PROJECT NAME  
**CHILDREN'S HOSPITAL  
OF ORANGE COUNTY**  
455 S. Main St.  
Orange, CA 92668-3874

ISSUE  
OSHPD PERMIT

DRAWING TITLE  
**LEVEL 7 REFLECTED  
CEILING PLAN AREA - D**

**A4.7D**

## B6 AREA D

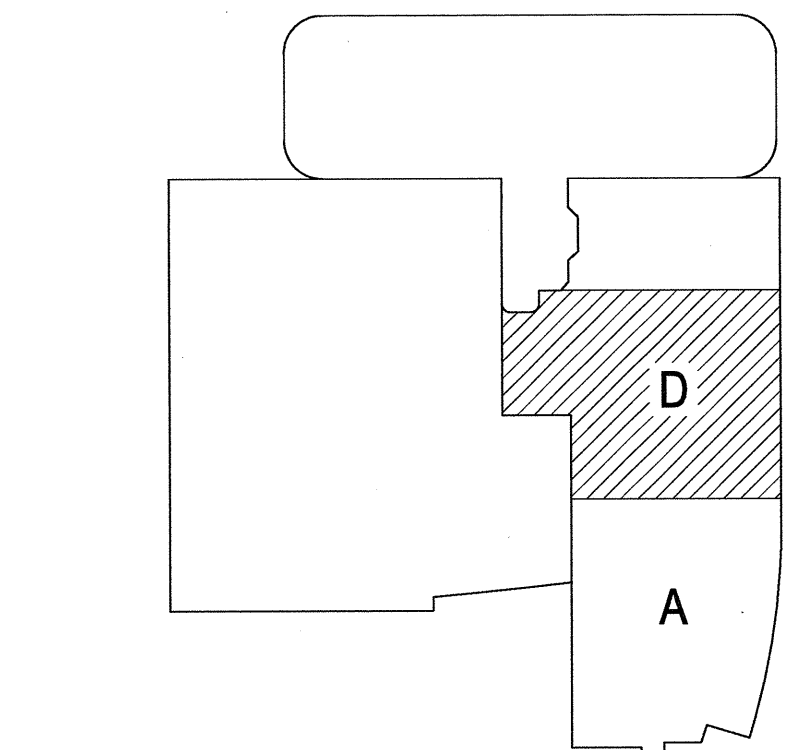
RFI 1018  
Refer to electrical lighting plans for light fixture locations in shell space.

RFI 4747  
Shade pocket to be installed per D1/A10.1

RFI 3897  
Soffit placed for egress lighting pocket

RFI 3897.1  
See detail for soffit height adjacent to ceiling
